EB1-12

Proponent: Jennifer Goupil, The Structural Engineering Institute of ASCE (jgoupil@asce.org)

EB3-12

EB4-12

FIGURE A3-7 - PARTIAL CRIPPLE STUD WALL ELEVATION

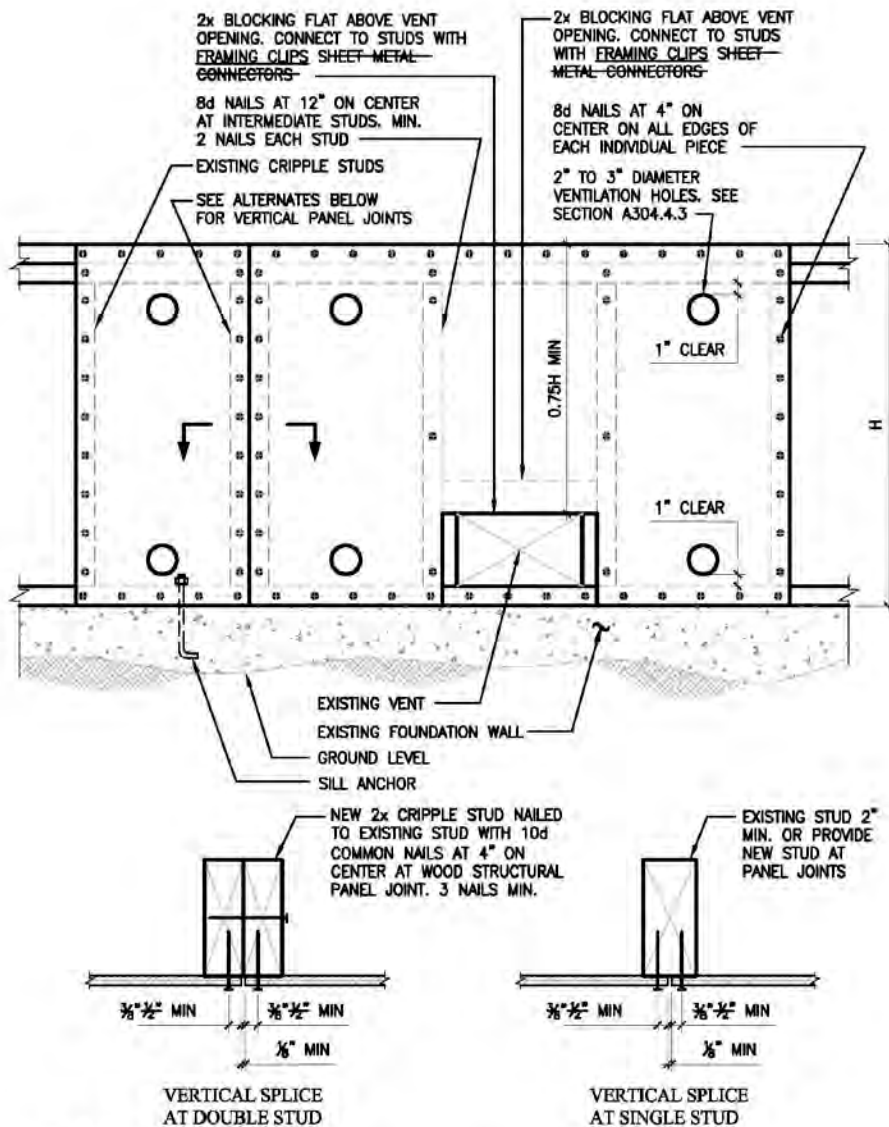
[B] A304.4.1.1 Sheathing installation requirements. Wood structural panel sheathing shall not be less than $1\frac{5}{32}$ -inch (12 mm) thick and shall be installed in accordance with Figure A3-5 or A3-6. All individual pieces of wood structural panels shall be nailed with 8d common nails spaced 4 inches (102 mm) on center at all edges and 12 inches (305 mm) on center at each intermediate support with not less than two nails for each stud. Nails shall be driven so that their heads are flush with the surface of the sheathing and shall penetrate the supporting member a minimum of $1\frac{1}{2}$ inches (38 mm). When a nail fractures the surface, it shall be left in place and not counted as part of the required nailing. A new 8d nail shall be located within 2 inches (51 mm) of the discounted nail and be hand-driven flush with the sheathing surface. Where the installation involves horizontal joints, those joints shall occur over nominal 2-inch by 4-inch (51 mm by 102 mm) blocking installed with the nominal 4-inch (102 mm) dimension against the face of the plywood.

Vertical joints at adjoining pieces of wood structural panels shall be centered on studs such that there is a minimum 1/8 inch (3.2 mm) between the panels, ~~and such that the nails are placed a minimum of 1/2 inch (12.7 mm) from the edges of the existing stud.~~ Where such required edge distances cannot be maintained because of the width of the existing stud, a new stud shall be added adjacent to the existing studs and connected in accordance with Figure A3-7.

Reason: This proposal revises the edge distance requirement to avoid a potential problem nailing into narrow existing studs. The current requirement, shown in Figure A3-7, puts the nail 1/2 inch from the plywood edge; with a 2x stud, this leaves too little edge distance into the stud. A 3/8 inch edge distance in the plywood is considered adequate for this application.

In addition to changing the edge distance in Figure A3-7, the proposal makes the following improvements:

- Removes the duplicative edge distance requirement from Section A304.4.1.1, deferring to Figure A3-7.
- Revises wording in Figure A3-7, from "sheet metal connectors" to "framing clips" for consistency.
- Defines the height of the cripple wall, H, in Figure A3-7.

FIGURE A3-4A: SILL PLATE BOLTING IN EXISTING FOUNDATION — ALTERNATE ALTERNATE SILL PLATE ANCHORING IN EXISTING FOUNDATION WITHOUT CRIPPLE WALLS AND FLOOR FRAMING NOT PARALLEL TO FOUNDATIONS

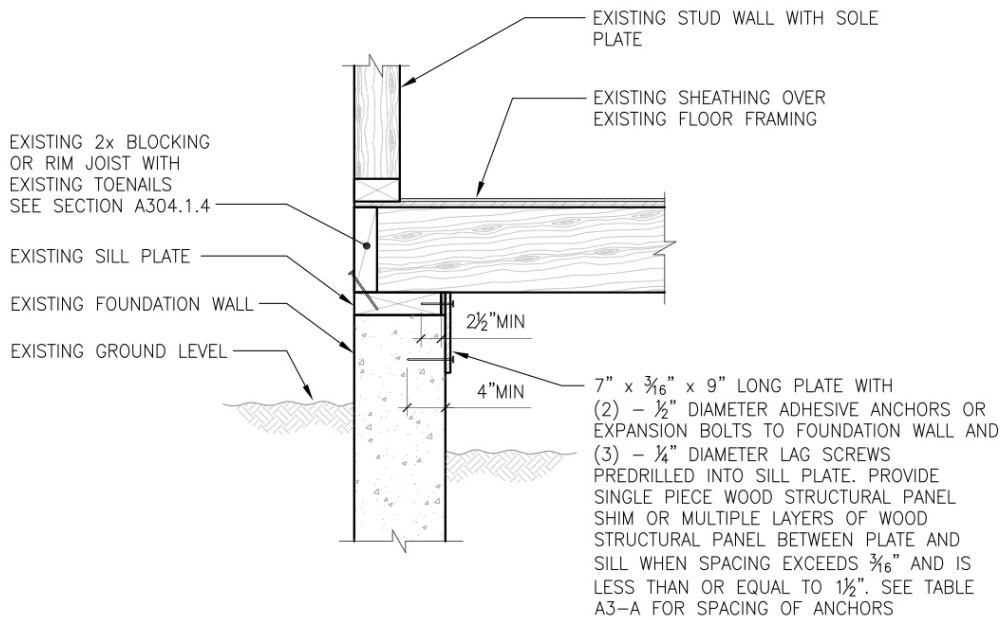
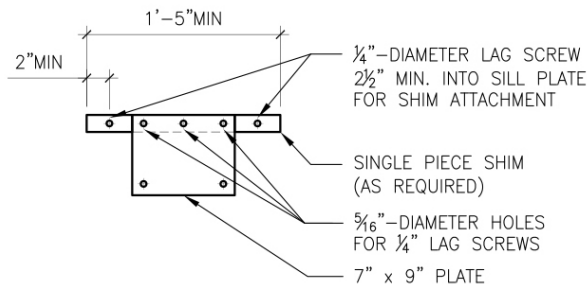
Revise Figure A3-4A as follows:

Where required, single piece shim shall be ~~foundation grade redwood~~ naturally durable wood or preservative-treated wood. If preservative-treated wood is used, it shall be isolated from the foundation system with a moisture barrier.

5. Correct [preferably through errata to the 2012 edition] and revise title:

HOLE DIAMETER SHALL NOT EXCEED CONNECTOR DIAMETER BY MORE THAN $\frac{1}{16}$ "

CONNECTION WHEN SHIM SPACE EXCEEDS $\frac{3}{4}$ " IN WIDTH UP TO $1\frac{1}{2}$ "

1. Correction of cited code section.
2. Editorial revision for consistent terminology ("anchor," not "bolt")
3. Errata. The correct value of $1\frac{1}{2}$ in. was in approved proposal EB54-09/10 but did not make it into print.
4. Editorial revision for consistency with current Section A304.2.6, which was revised for 2012.
5. Errata, with one editorial change for 2015. The correct title, "Alternate sill plate ...", was in approved proposal EB54-09/10 but did not make it into print. That approved title actually read "Alternate sill plate bolting in existing foundation ...". For terminology consistency, it should now read as proposed here: "Alternate sill plate anchoring in existing foundation ...".

FIGURE A3-10—FLOOR PLAN—CRIPPLE WALL BRACING LAYOUT

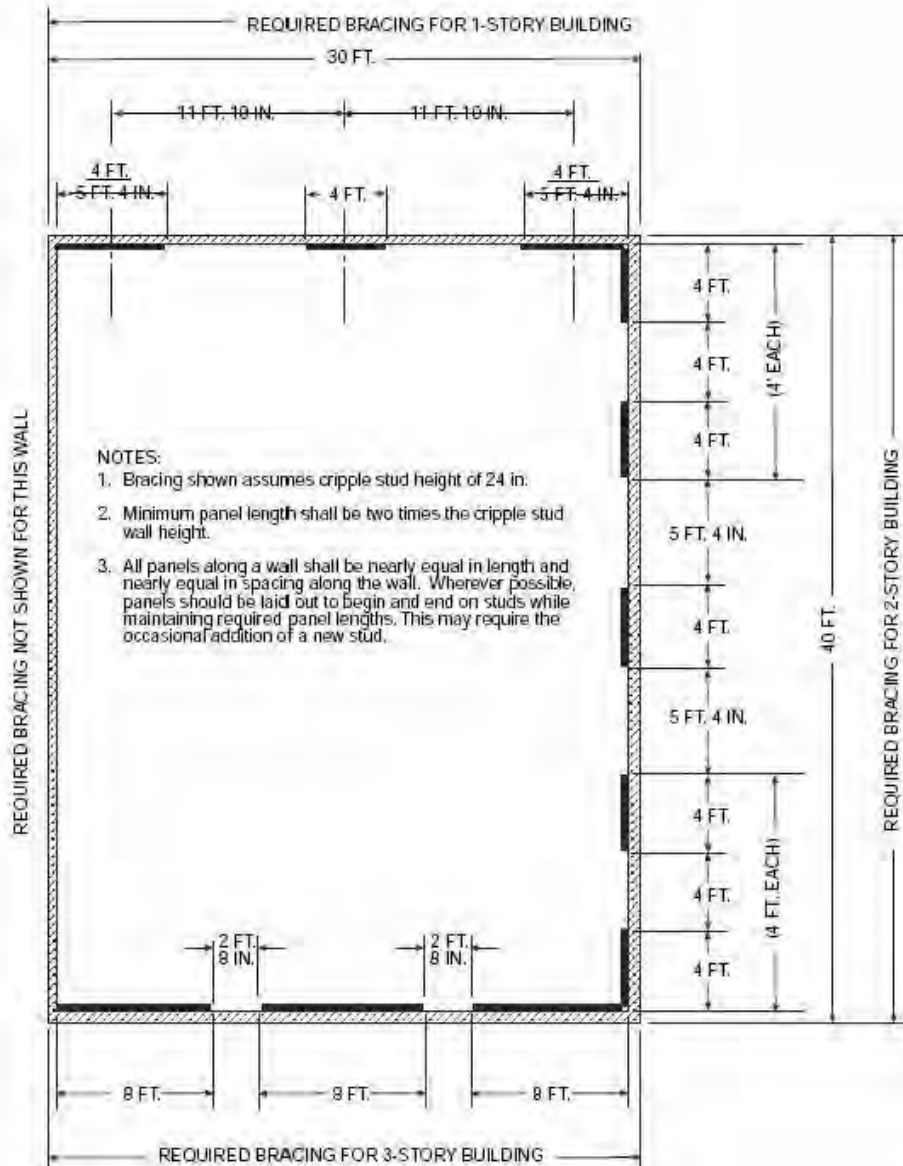
Revise Figure A3-10 as follows:

Reason: The proposal corrects the dimensions shown at the top of Figure A3-10 for 1-story buildings. The calculations at the bottom of the figure are correct, so the figure should be revised in three ways:

- Delete the dimension strings showing 11'-10" spacing between panel centers.
- Change the end panel lengths from 5'-4" to 4'-0" in two places.
- Redraw the end panel lengths to approximate scale as 4-ft long sections.
